MYO FINAL MONITORING REPORT

Cool Run Stream and Riparian Wetland Mitigation Site

**Re: Cool Run– MYO As-Built Report– Response to Comments (DMS Project No. 100142)
USACE Action ID No. SAW-2020-01428 / DWR Project No. 20200712**

Please find below the response to comments for the Cool Run MY0 As-Built Report provided on August 11, 2023:

**FIGURE
 1**

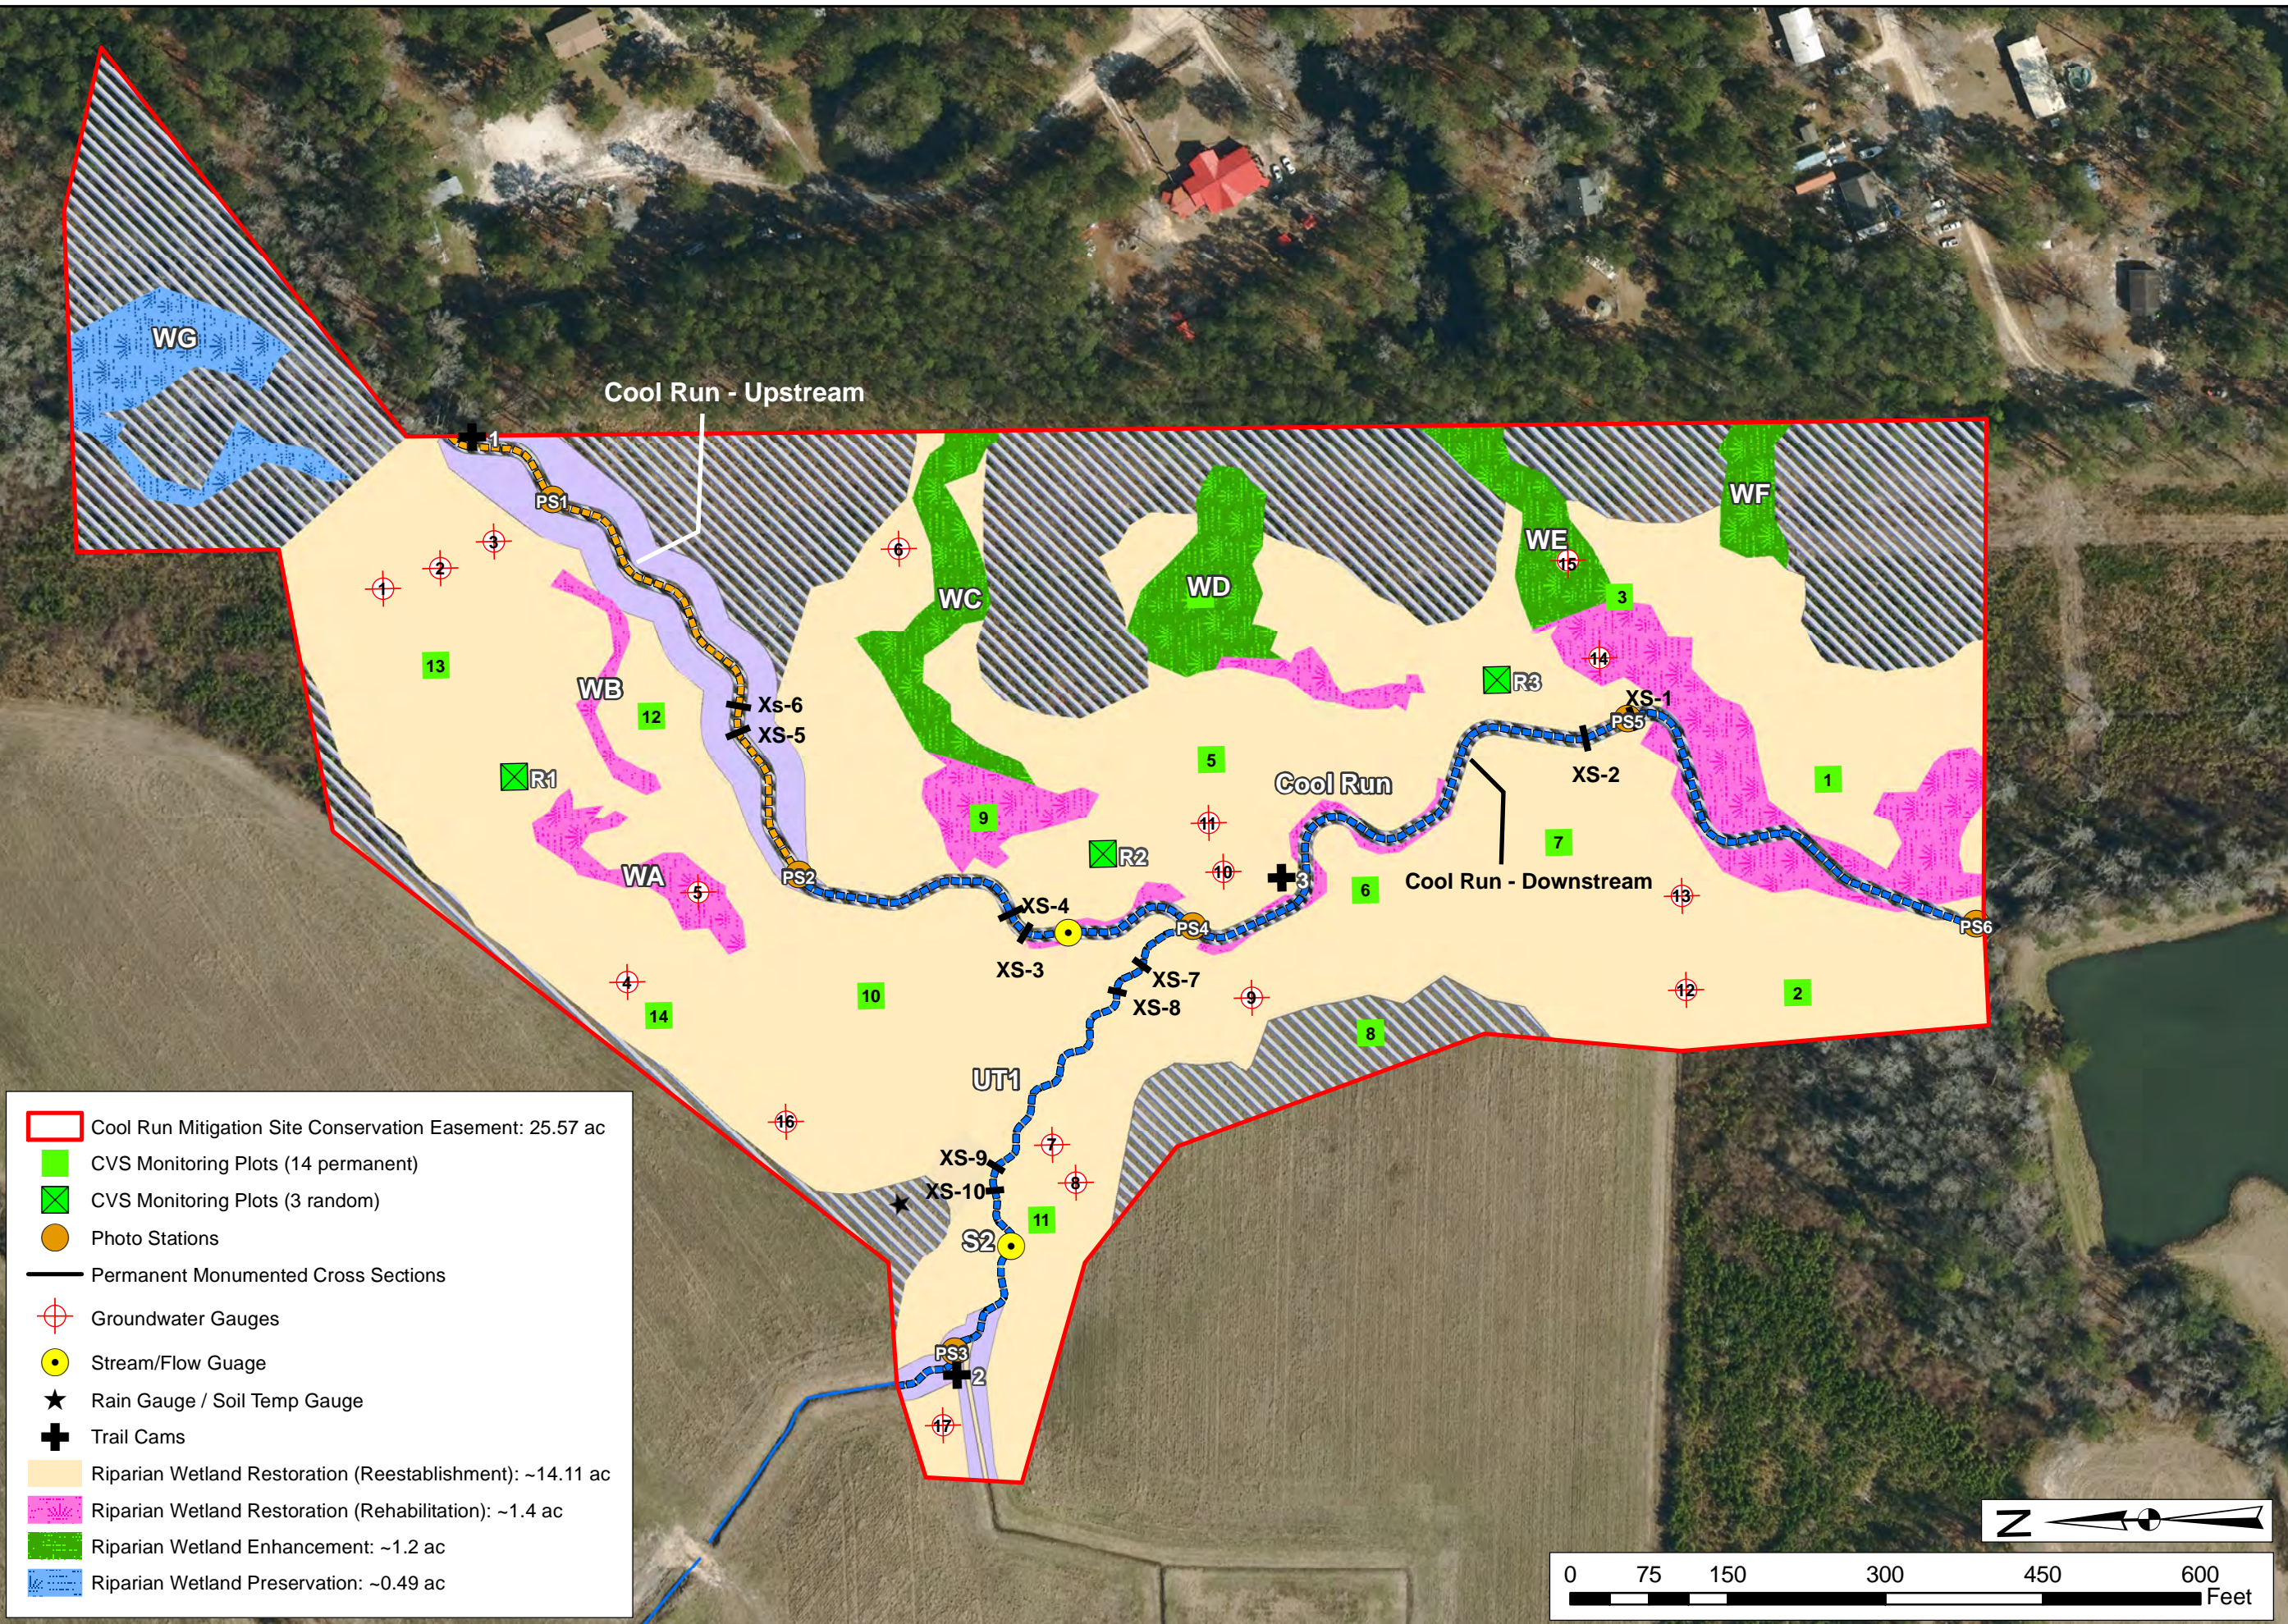
5. CCPV (Figure 1)
- Please color code all veg plots based on meeting (green) or not meeting (red) vegetative success criteria. Please do the same with wetland monitoring wells in MY1.
 - Recommend differentiating stream gauges based on their intent, i.e., to monitor overbank events, or flow, or both.
 - Recommend removing the old ditch labeling NS2, NS3, etc.
 - It may be helpful for reviewers to label UT1 and Cool Run's different reaches on the map.

Re: Corrected per recommendations.

SHEET NO.
AB-04D

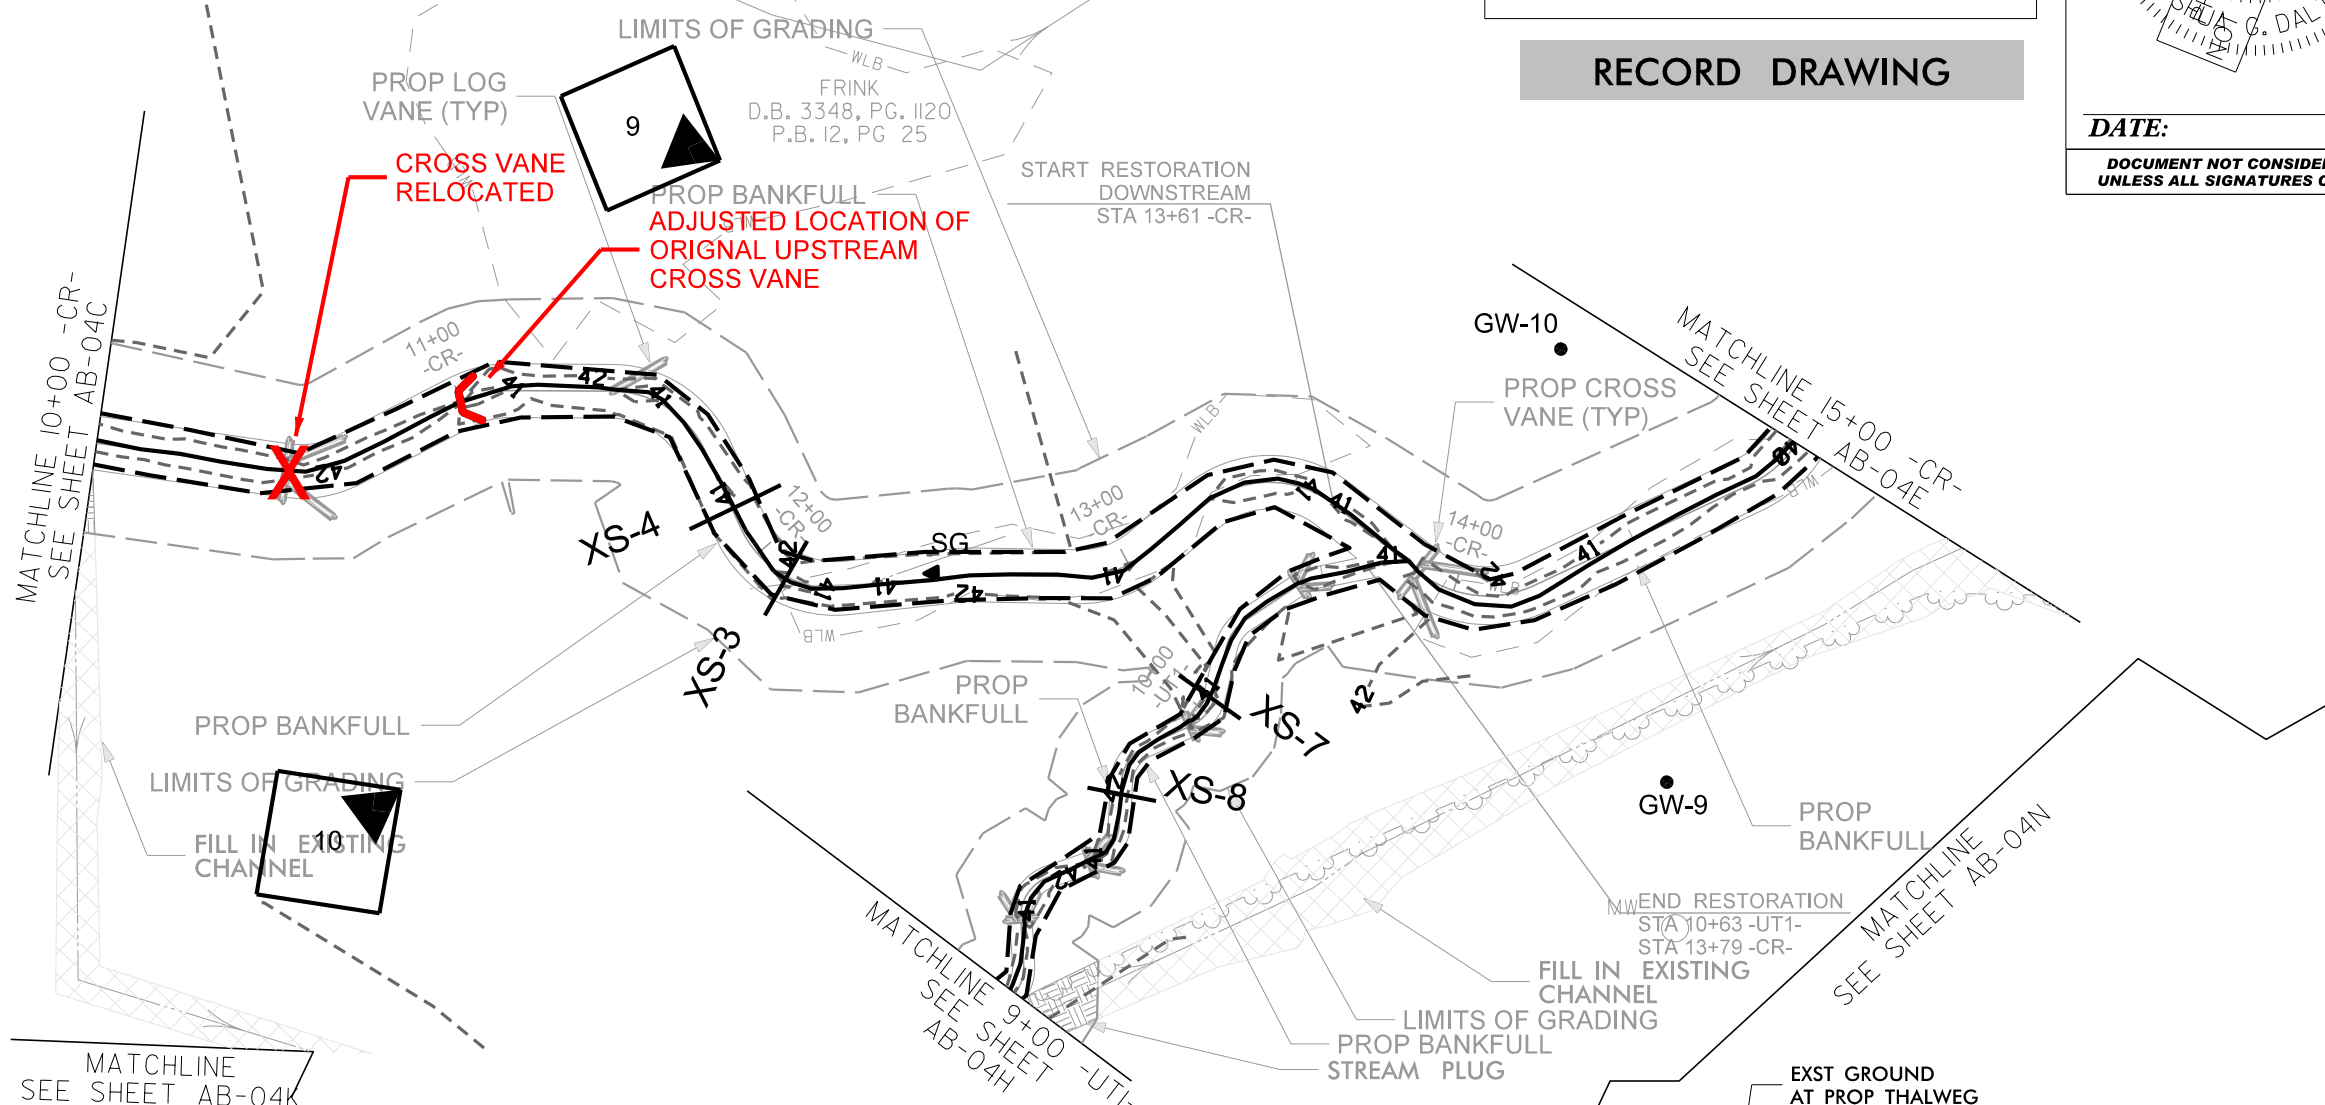
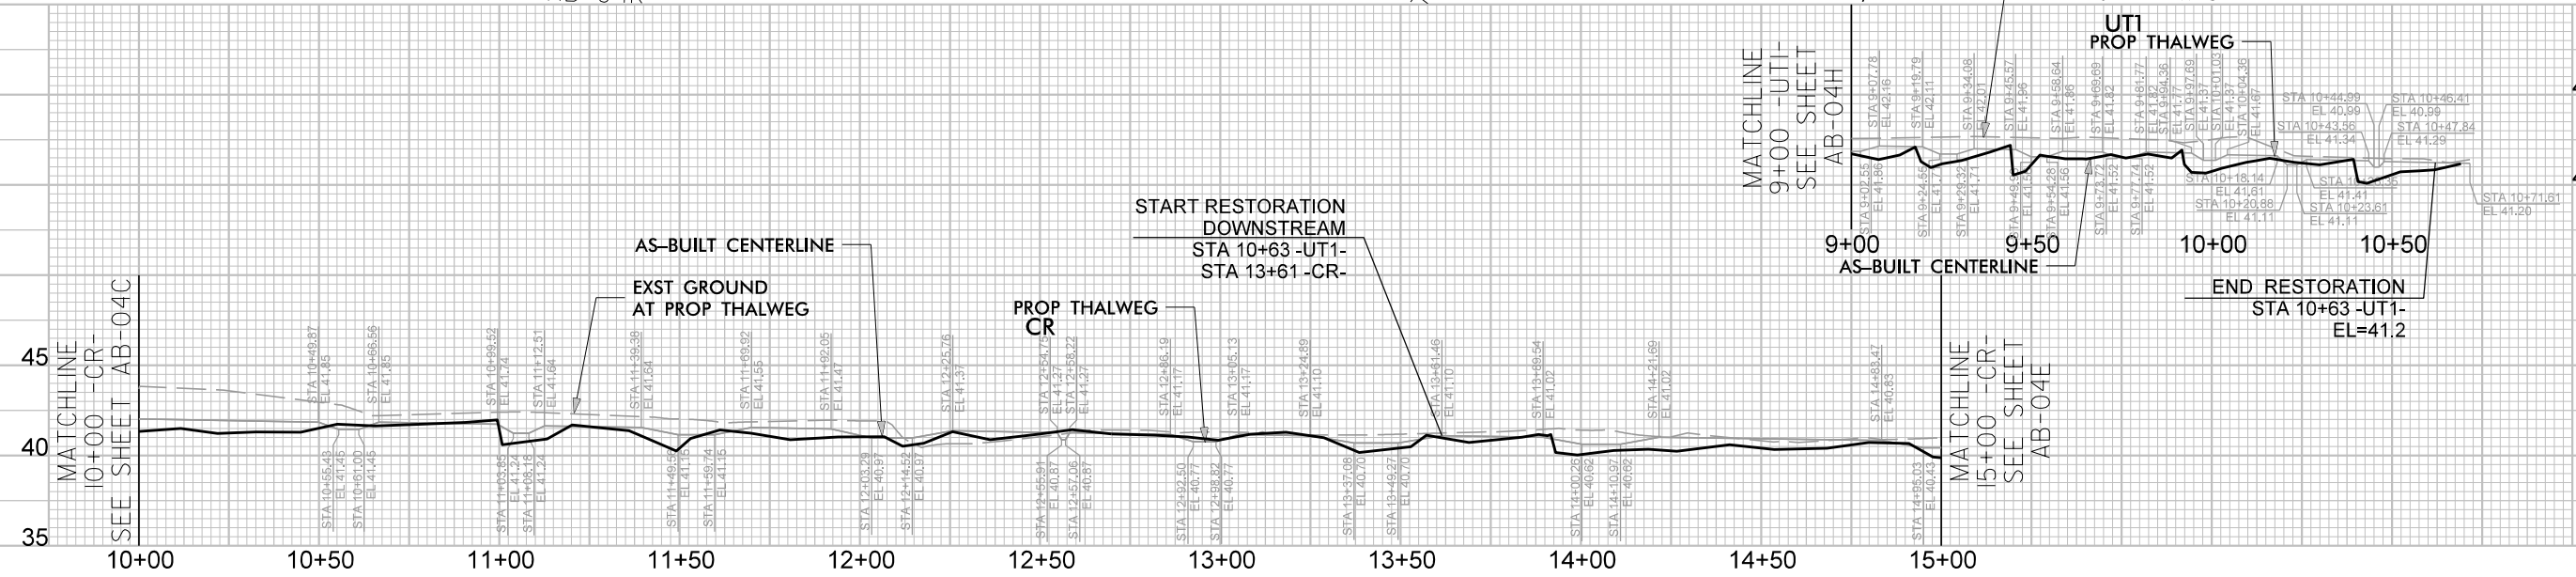
9. Sheet AB-04D – recommend keeping the “Cross Vane Relocated” callout and in addition coloring the relocated cross vane red, or adding an arrow to draw attention to indicate that it is the structure that was moved.

Re: Corrected per recommendations.
